Access Compliance Report Public Rights-of-Way (Curb Ramps)

Main Street: FARMHOUSE Cross Street: UNIVERSITY_AVE Location: NW

ADA ID: RPRK220223163110 Ramp Type: Type 4 - Parallel Initial Pass/Fail: Fail Overall Compliance: No Severity Score: 2

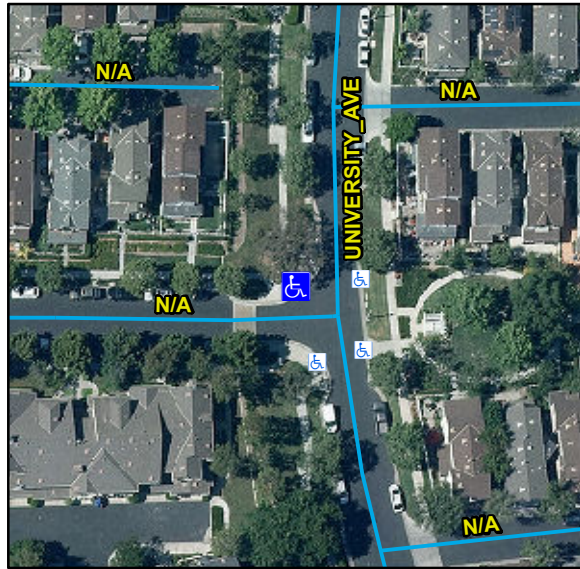
Compliance	Description	Data	Compliance	Description	Data
N/A	Ramp Length LT (in)	144	N/A	Ramp Length RT (in)	142
Yes	Ramp Width LT (in)	89	Yes	Ramp Width RT (in)	89
Yes	Ramp Run Slope LT (%)	2.6	Yes	Ramp Run Slope RT (%)	6.9
No	Ramp Cross Slope LT (%)	2.5	Yes	Ramp Cross Slope RT (%)	0.9
N/A	Landing Present	N/A	N/A	DWS Provided	N/A
N/A	Landing Length (in)	N/A	N/A	DWS Contrast	N/A
N/A	Landing Width (in)	N/A	N/A	DWS Length (in)	N/A
N/A	Landing Run Slope (%)	N/A	N/A	DWS Full Width	N/A
N/A	Landing Cross Slope (%)	N/A		DWS Offset Type	N/A
N/A	Landing Movement Obstructed?	N/A	N/A	DWS Offset Left (in)	N/A
	Landing Movement Type	N/A	N/A	DWS Offset Right (in)	N/A
N/A	Landing Shared	N/A			
N/A	Clear Space	Yes			
N/A	Clear Space To Crosswalk (in)	48			
N/A	Marked Crosswalk 1	No	N/A	Marked Crosswalk 2	No
	Crossing 1 Direction	S		Crossing 2 Direction	E
	Marked Crosswalk 1 Width (in)	N/A		Marked Crosswalk 2 Width (in)	N/A

Remove & Replace Curb Ramp With Two New Directional Ramps or Equivalent.
